ADDENDUM NO. 1
January 27, 2026

ValePointe Phase I Improvements
Valley Center, KS

From: Short Elliott Hendrickson Inc.
15750 Dodge Rd, Suite 304 Omaha, NE 68118

TYPE 1A CURB INLET DETAILS

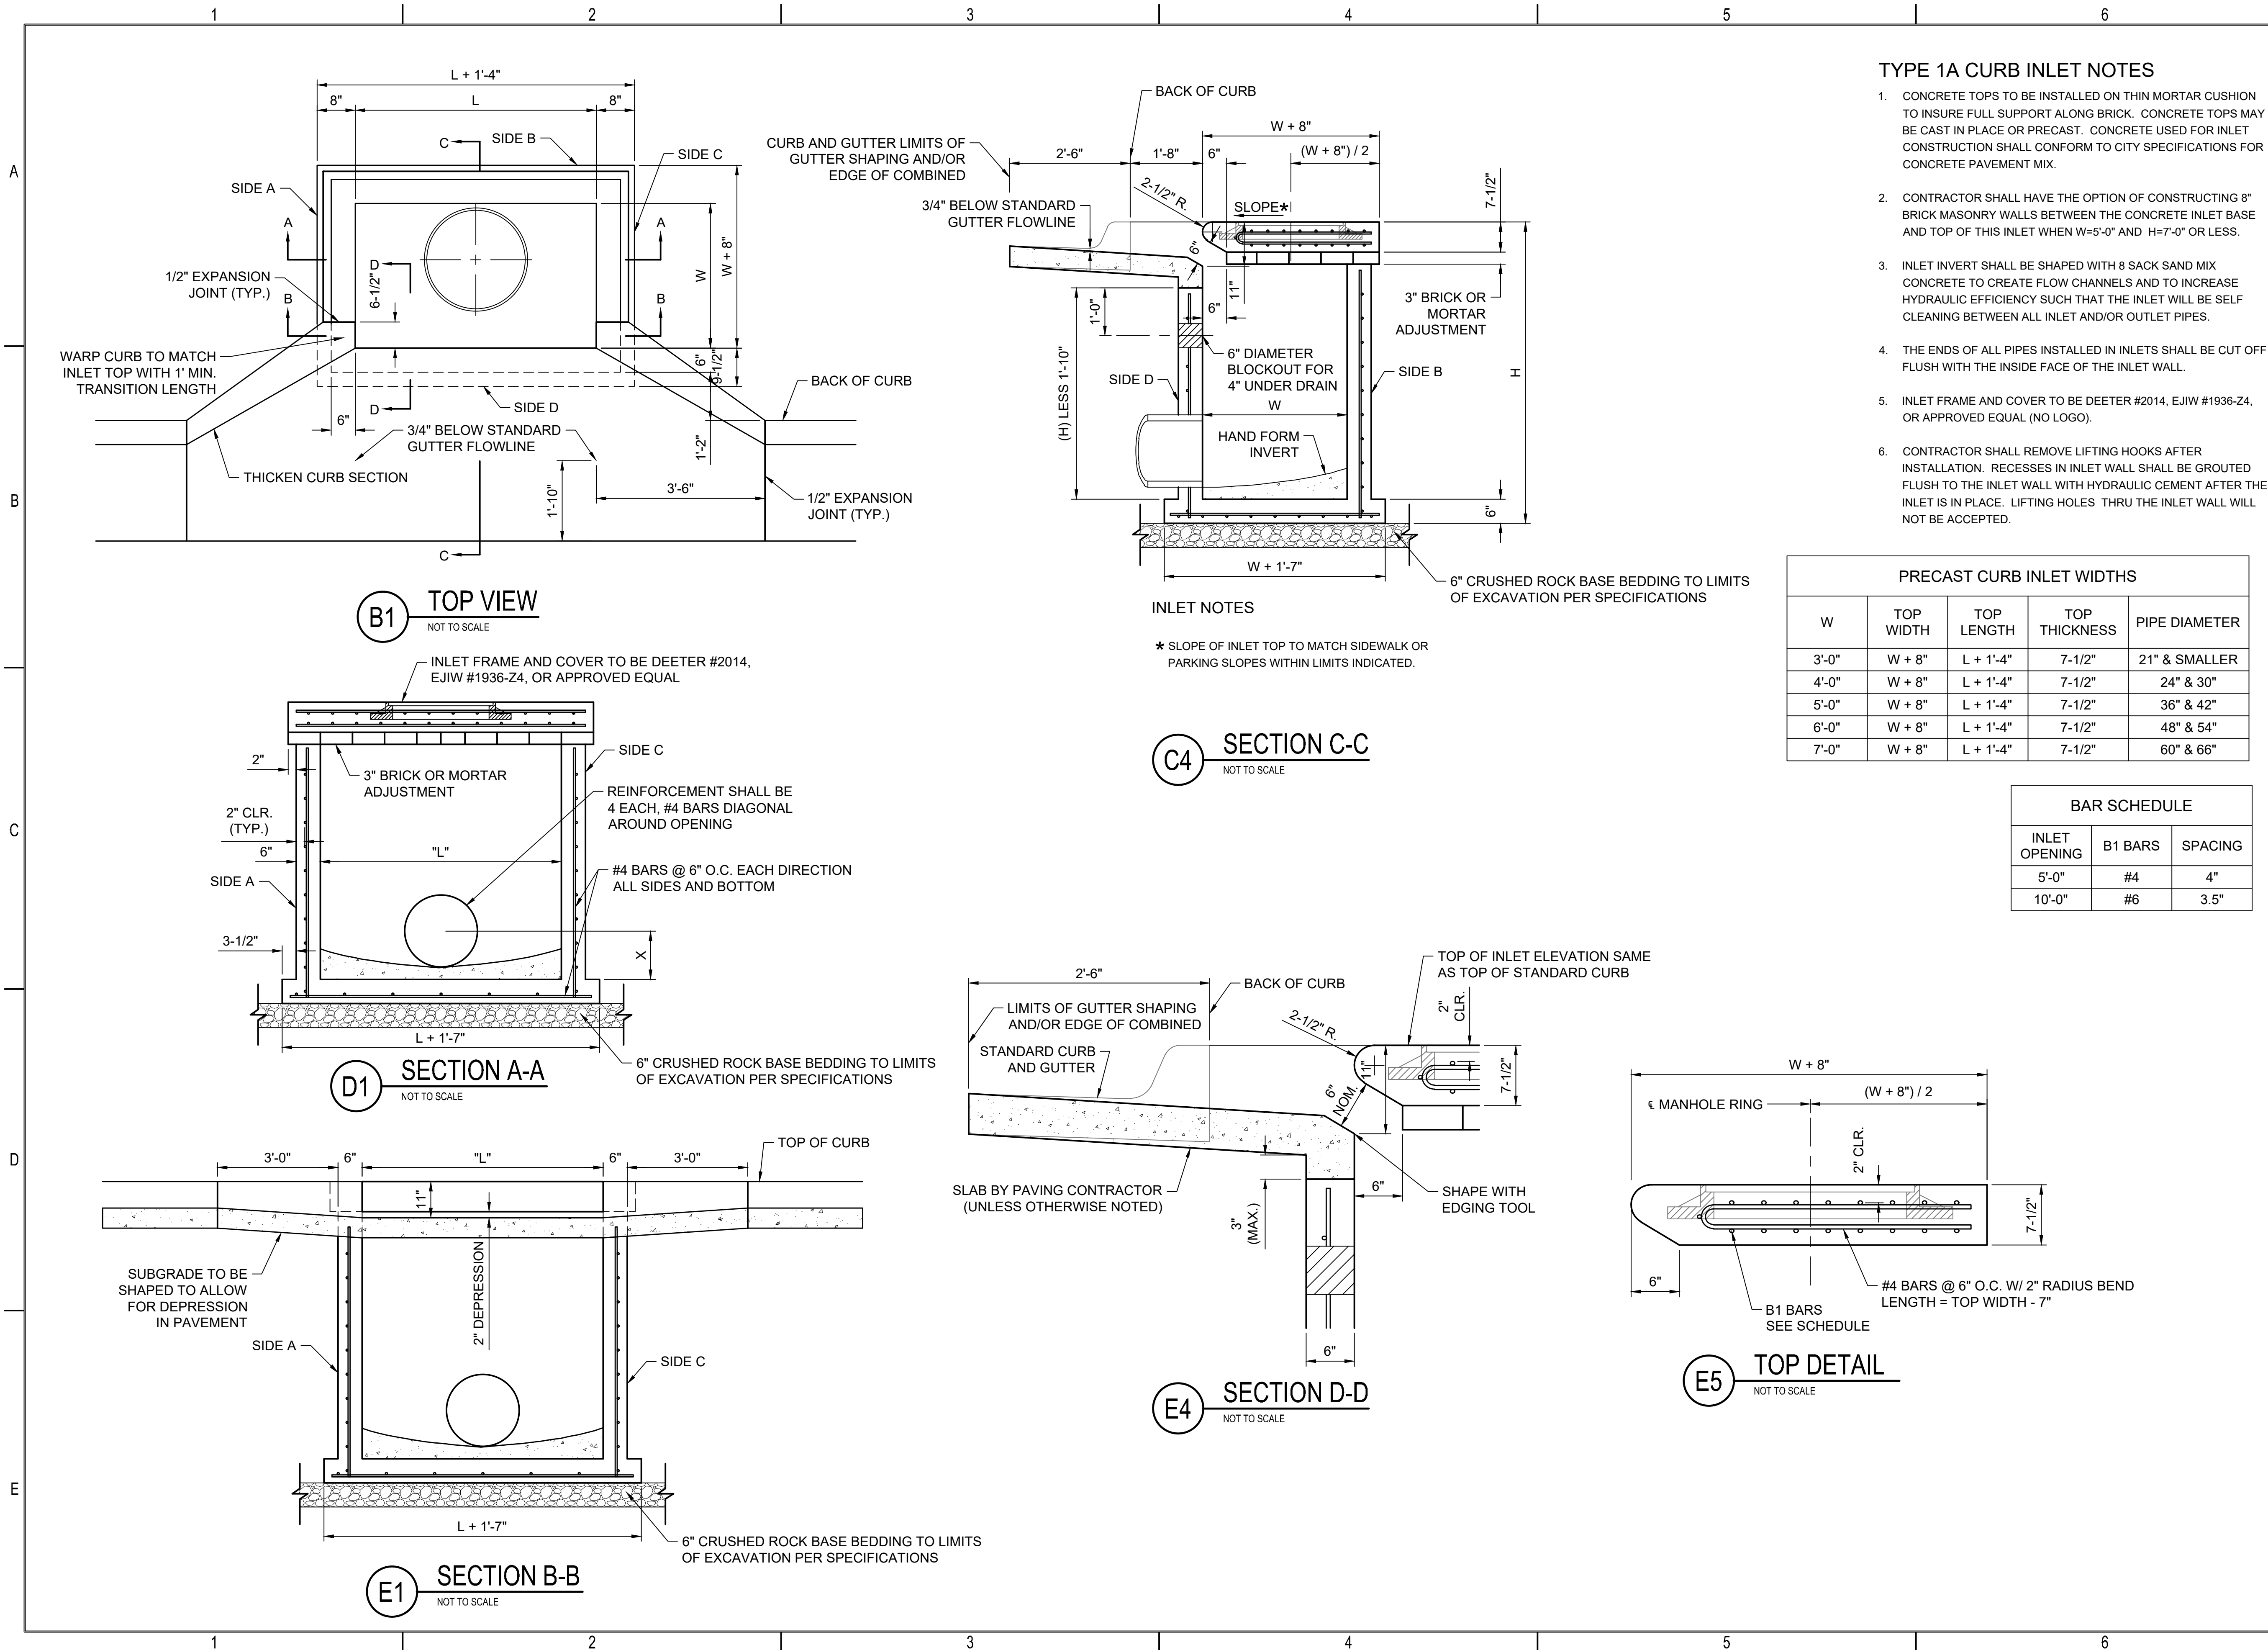
9. All design CAD files will be provided to the contractor prior to construction, which shall include .dwg and .xml files.
10. The plans call out Type I Curb Inlets. The city has communicated that they prefer Type IA curb inlets. The Curb Inlets provided shall be Type IA inlets, shown in the attached detail. Bid Form has been updated.
